Oil Injection Pump Sport Jet

Models Affected

1995 SPORT JET 90 & 120
S/N 0E125390 - 0E141088

1996 SPORT JET 95XR & 120XR
S/N 0E141089 - 0E200011

- a - Oil Pump Lever
- b - Alignment Mark
(At Wide Open Throttle)
- c - Pump Alignment Mark
- d - Link Rod

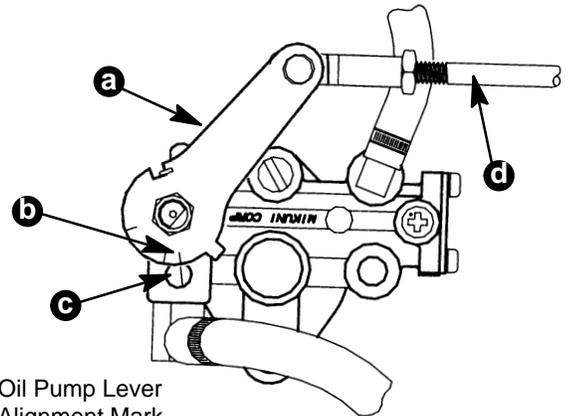
There have been sporadic reports of Sport Jet powerheads scoring pistons during the break-in period. Engineering had found that the oil injection pump has not been consistently adjusted to provide the correct ratio of oil at wide open throttle. Several engines were found where the oil injection pump was metering oil at 70:1 rather than 50:1.

This was caused by a change where the fixed wide open throttle stop was replaced by an adjustable stop. The adjustable stop was necessary to increase the idle timing to achieve the 1000 rpm idle speed with a closed throttle shutter. The closed throttle shutter is a requirement for the Turn Key Start feature.

To correct this potential problem, the procedure for adjusting the oil injection pump has been changed. The oil injection pump is now adjusted at wide open throttle position rather than at idle.

1. Move towershaft to the Wide Open Throttle position. Inspect oil injection pump alignment mark (c) with the oil pump lever mark (b). This check may require the use of a small mirror.

2. Adjust oil pump link rod (d) to align the marks as necessary.
